Public Design Workshop 3

Public Design Workshop 3 - Site Scheme Alternatives

Circulation Scheme B

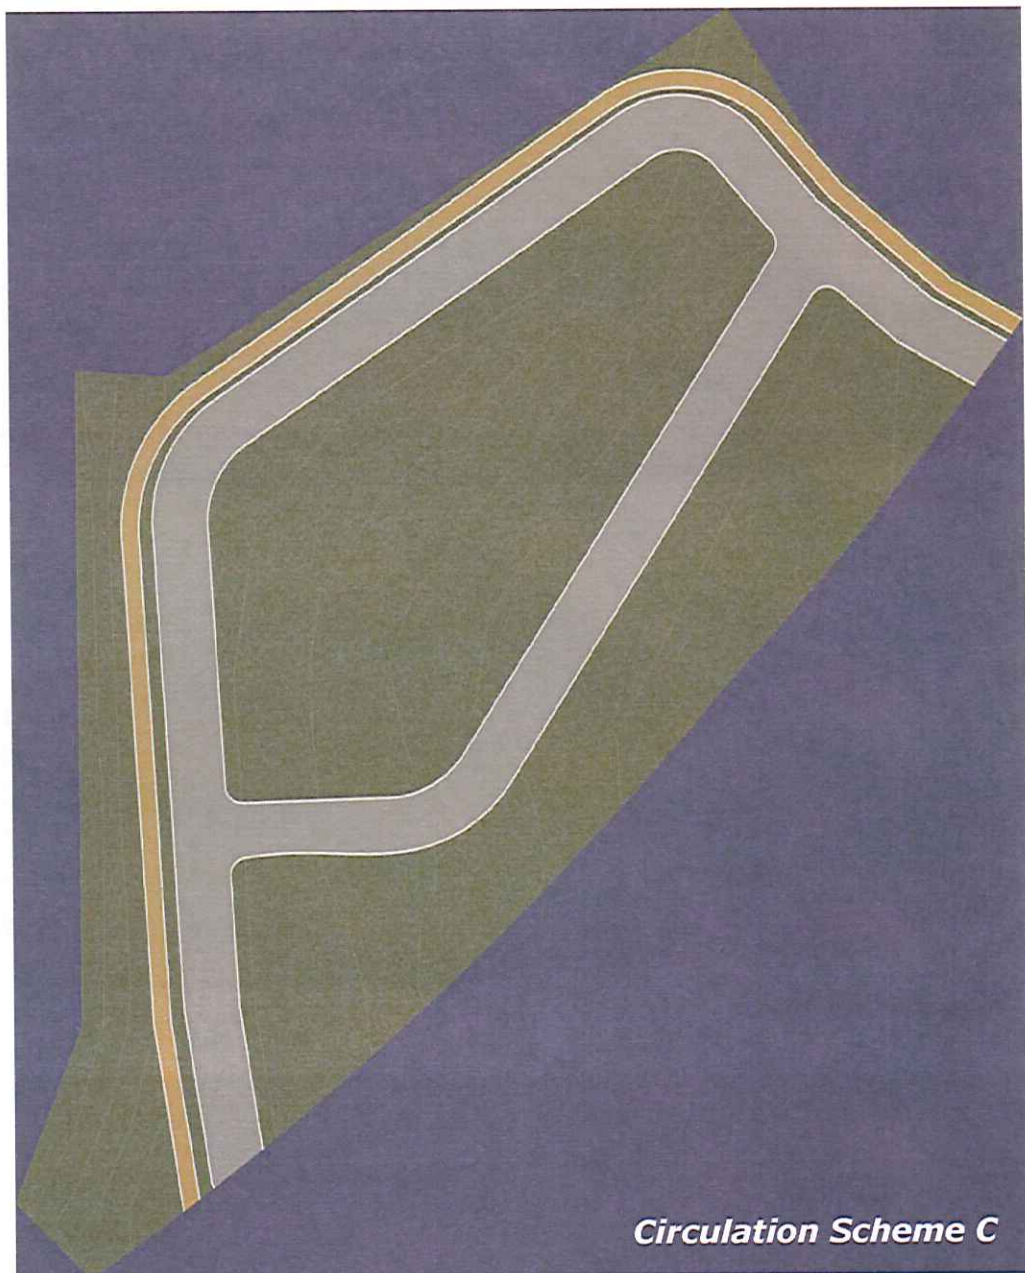
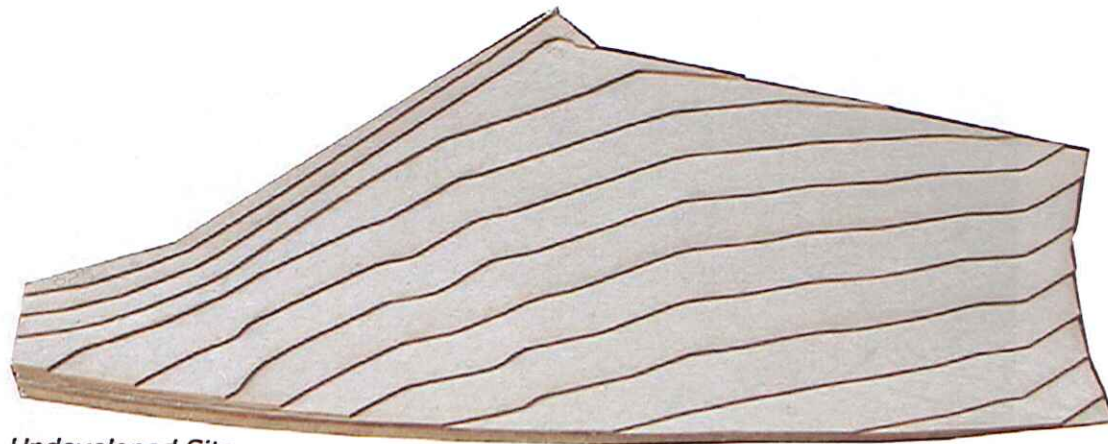
Public comments:

- Keep single family homes - no duplexes, triplexes, apts. etc.!! No more than 20-25 total.
- Good Plan
- Seems suitable to surrounding area.
- Worried about City owning the land

- Middle area for an open space-park area with housing around road way would be great!
- Worried about drainage
- Good plan if you eliminate one entrance. (One on the right.)

- Has to have 2 entrances
- No low income - No duplexes
- Liked this the best. 15 homes at most - Trail - Park - Single story
- Like this one the best - Traffic openings are safer - Single story unattached houses - Houses need HOA

- House should not be attached - No tri-level
- No Low Income Housing
- This entry/exit better for visibility (Drawing refers to southern entrance)
- Separate houses unattached - more senior housing - No tri level homes

- Two openings for fire safety
- Only one entry on Cliffs Pkwy!
- Cliff Highway needs revamping for safety. Can't see cars. Need stops signs - Cars go too fast on Cliff Highway - Must have HOA

Circulation Scheme C

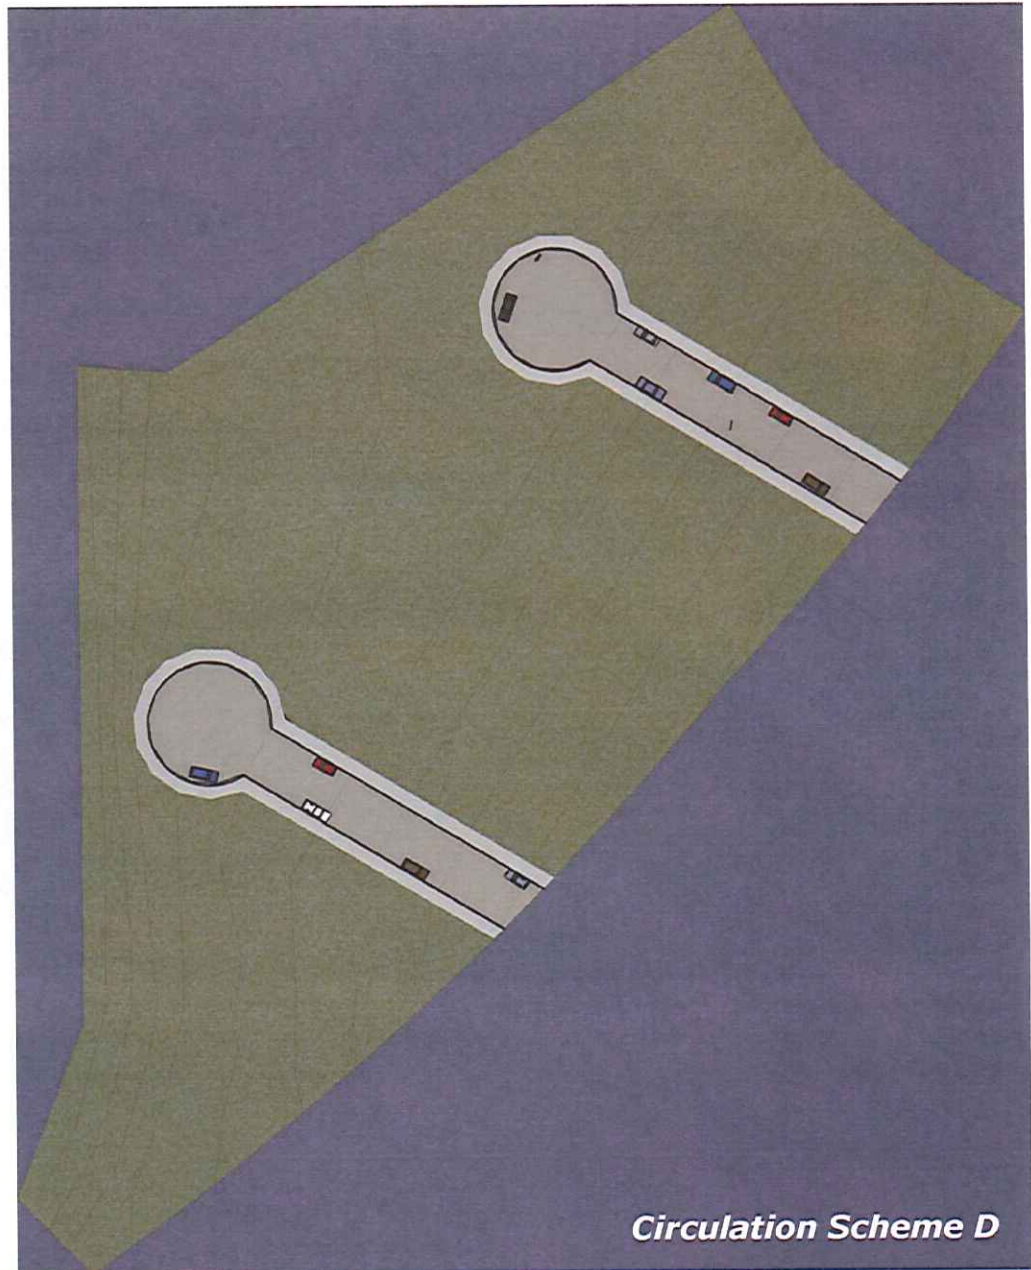
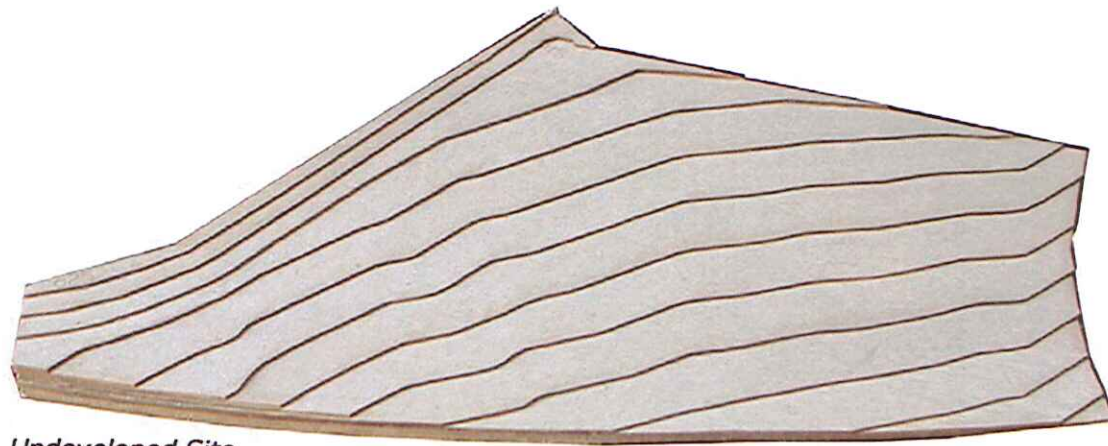
- No thanks!
- Would make too much traffic noise at back of custom homes above!
- On all plans with 2 entrances...NO..Should be only one entrance onto Cliffs due to blind hill + curves. It's already dangerous.
- I can't imagine how the trailway would look in terms of being a nice landscaped area when it is along side a road.
- Agree!
- I agree
- Walkway between wall and road is not pleasant.
- Nice long walking path
- No low income housing
- Eliminate one entrance to Cliffs Pkwy. Diagram indicates northern entrance. There is already a safety problem due to hills and curves.
- No walkway here so close to existing homes + our backyards! Diagram indicates northern property line.
- I agree
- Traffic + walking too close to homes above.
- 'Kids' may use a street as a raceway if there are 2 entrances. Already happens on Cliffs.
- No tri-level or duplex houses, a split-level

Circulation Scheme D

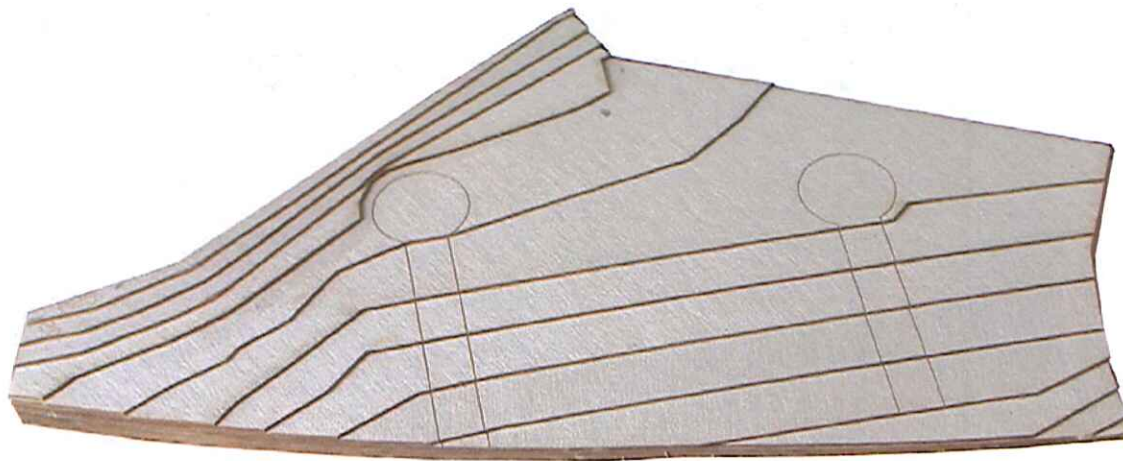
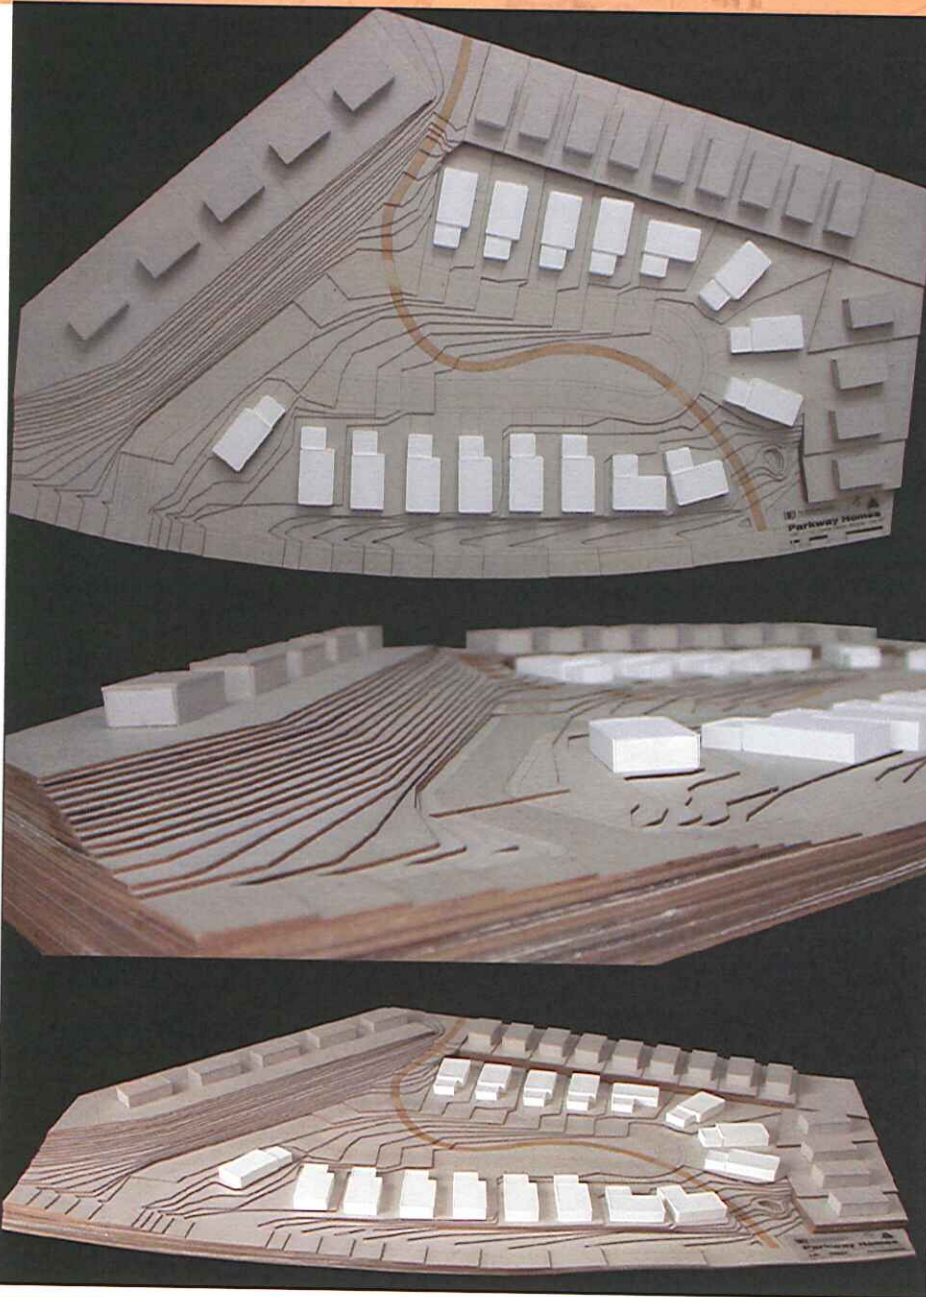
- Comments and Feedback
- No Way!
- No!
- ICH!
- No tri-level - Split level
- I like more roads, less housing
- No way
- Stupid!!
- Why not angle? Diagram of streets indicates a northwest direction of roads.
- Bad idea! Traffic flow wrong - No low income housing
- Don't like this one. There seems less opportunity for homes
- Again, this is 2 entrances...only need one.
- Need 2 roads
- Sell land to developer, use money to build library.
- Amen!
- Build housing for the poor - not BA Grads.

Scheme A

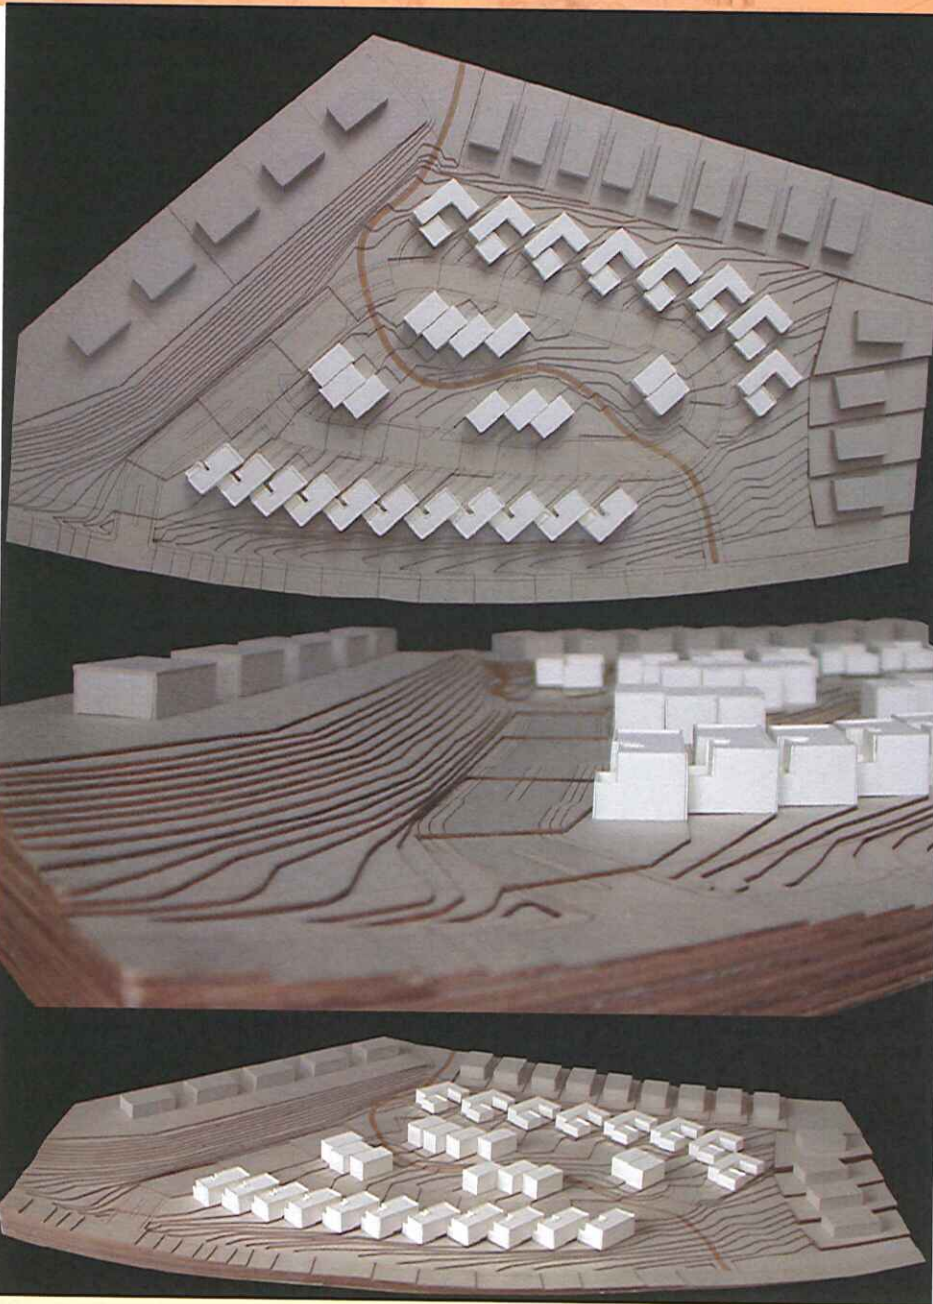
- Can this be a great community?
- Can you fit a few more houses?
- Can this scheme be tweaked more so it uses space better? Maybe have less park area and more homes. This seems to blend in the best with area.

- Why can't you orient these homes like the top ones in plan B
- In terms of \$ for library, how does this compare with 25 houses on scheme #2
- Can you design the homes to make better use of light? –answer this!

- Not great but better than the rest
- This design does not maximize the profit of the library – to bad
- Yes!!!
- I don't favor this because it is not dense enough for the purpose of doing it, it would be a waste of this valuable property.

- Walking pass as it meets cliff parkway should not be perpendicular. Need to "y", include bushes to eliminate bikes and skateboarders from going straight into street.

- Very nice
- Best of all it need to be.
- Yes! Very nice
- Very nice, love the plan
- Of the three, I like this one because it will blend into the rest of the community, more than the others

- Yes, by for the best, no two story
- Nice place to play and hang out, and instead of us playing in the street
- Love the one way around the park and trail

- I think this has the least impact in terms of having too many people in this small area
- This scheme is the only one that fits with other sub div near by, if it must be.

Scheme C

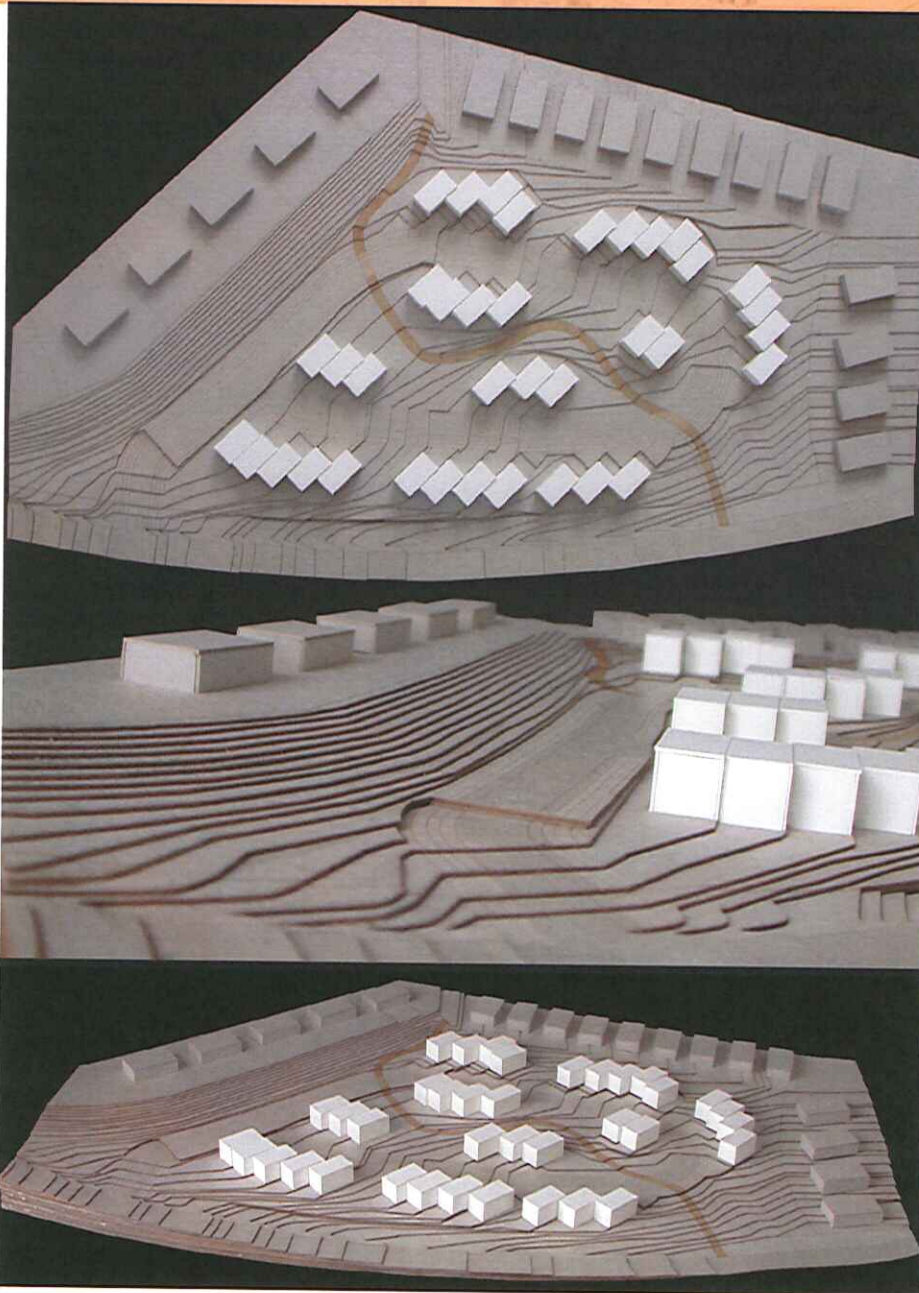
- This scheme seems to fit Flag near N.A.U. not Camp Verde
- NO, no place for kids to play or hang out!
- No!
- Re: number of units – what is the minimum for the best \$ for library.
- No, I would like park with no houses
- No! No! Parking will be a nightmare
- I like the extra open space but this is way too many units! A big No to that.
- No two story
- No way! Too many two-story not acceptable - re \$ for all owners
- Great plan / design - two story doesn't affect lower grades across street – the increase in open space is great
- Great plan, go for it!!
- This is also a good plan and the two stories are no problem with the elevation drop
- Town homes add a nice alternative to current options
- I like the cluster housing and extra open space.
